Nomad

SERVICE BULLETIN

RUDDER CONTROL SYSTEM – STRENGTHENING OF CABLE PULLEY MOUNTING AT STA 74.52 (MOD N630)

Figure 1 Installation of Flanged Bush (Post Mod N630)

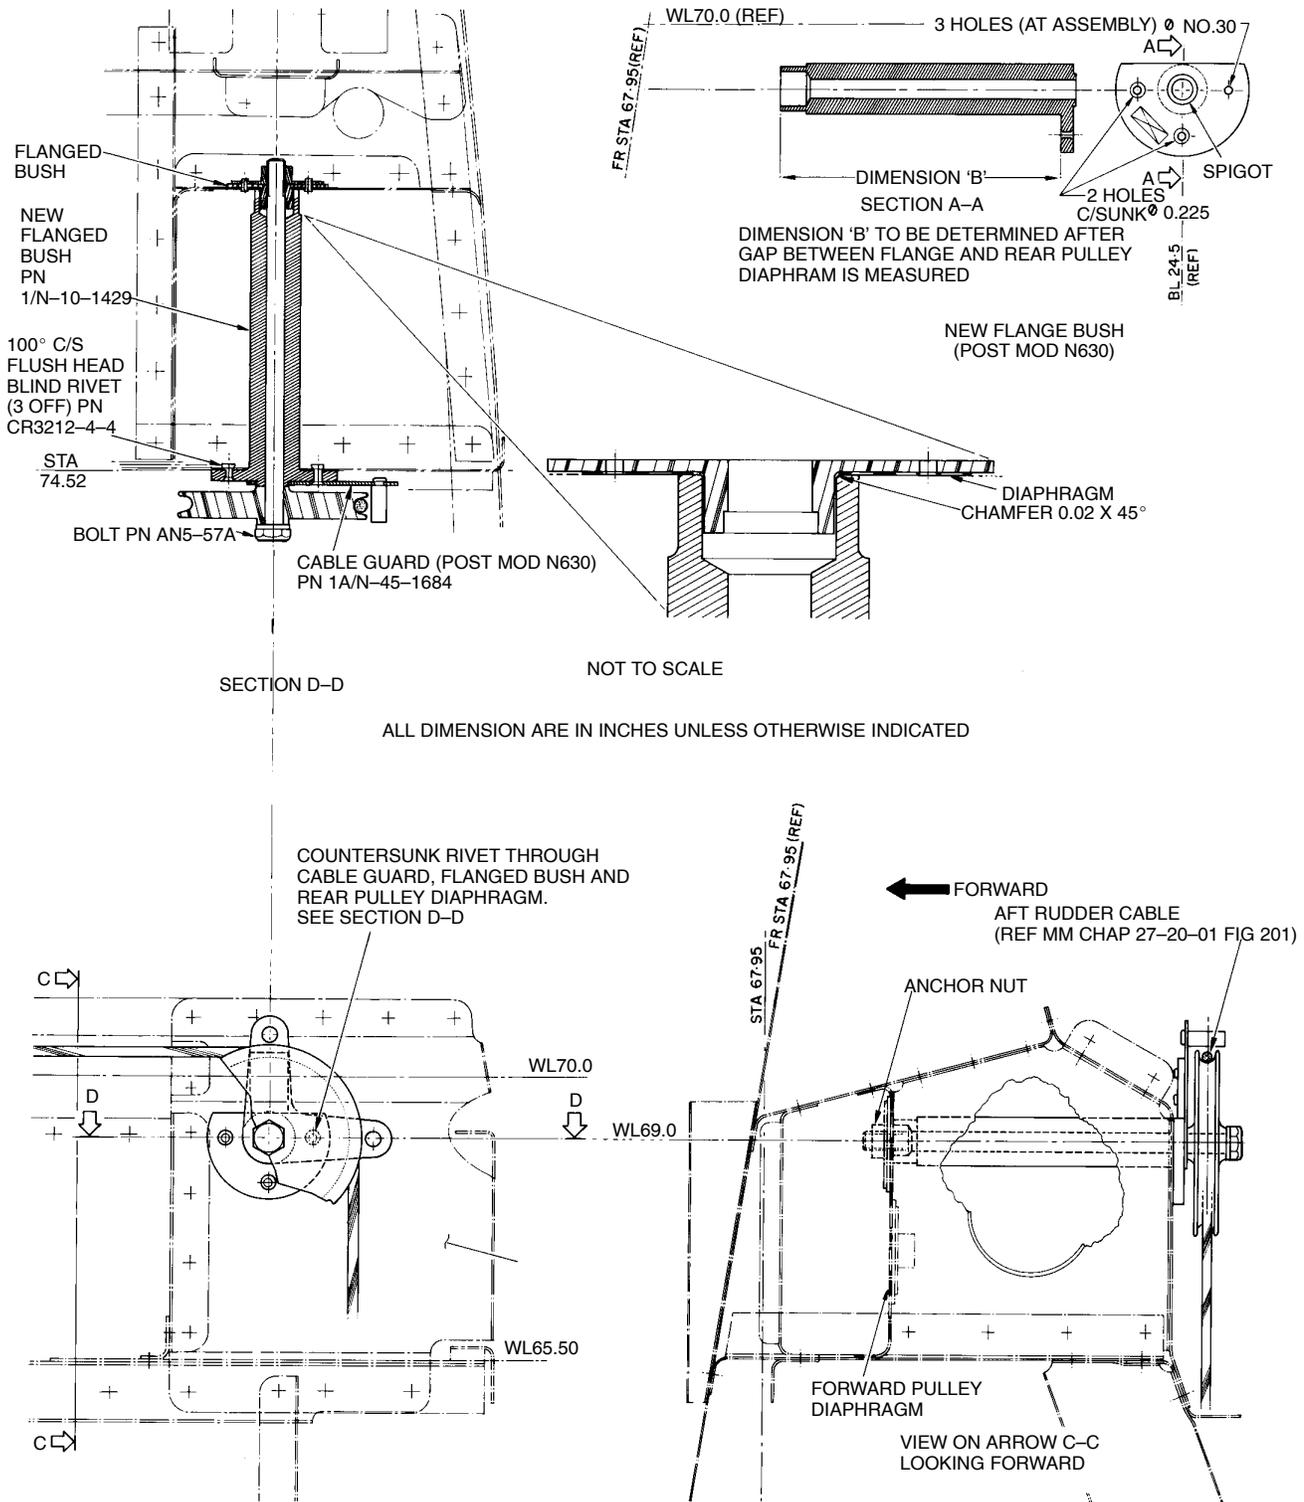
The existing flanged bush and spacer tube, supporting the cable pulley mounting bolt, are replaced by a flanged bush with an integral spacer tube.

- E. Open up the pulley mounting bolt hole in the rear pulley mounting diaphragm to 13/16 inch dia (20.5mm).
- F. Open up the bolt hole in the cable guard and the flanged bush (removed at step D.) to 1/2 inch dia (12.5mm).
- G. Using the reworked flanged bush as a drill guide, drill three rivet holes in the flange of the new flanged bush PN 1/N-10-1429 using a No.30 drill.
- H. Assemble the cable guard onto the spigot of the new flanged bush as shown in Figure 1, i.e. in its normal position relative to the pulley, then back drill the cable guard at one position using a No.30 drill.
- I. Remove the cable guard and countersink the rear face of the rivet hole in the guard to suit 100° countersunk flush head rivet PN CR3212-4-4. Re-part number the cable guard to 1A/N-45-1684.

Similarly countersink the rivet holes on the new flanged bush except for the rivet hole used as a drill guide for drilling the cable guard.
- J. Insert the shaft of the new flanged bush through the 13/16 inch dia hole in the rear pulley mounting diaphragm and push forward until the counterbored end of the flanged bush is firmly seated on the spigot of the flanged bush riveted to the forward pulley mounting diaphragm.

- K. Using a set of feeler gauges measure the gap between the flange of the new flanged bush and the rear face of the rear diaphragm. Note gap dimension.

- L. Remove the new flanged bush from its installed position and machine metal from the counterbored end, an amount equal to the gap dimension obtained at step K. Restore the chamfer .02 x 45° to the counterbore at the machined end of the flanged bush. Remove all sharp edges then touch up all reworked bare metal with primers.

- M. Assemble the new flanged bush into its installed position (Ref step J.) and with the cable guard on the spigot of the bush. Align the rivet holes of the new flanged bush and cable guard with the three rivet holes in the pulley mounting diaphragm then rivet up using 100° countersunk flush head rivets PN CR3212-4-4.
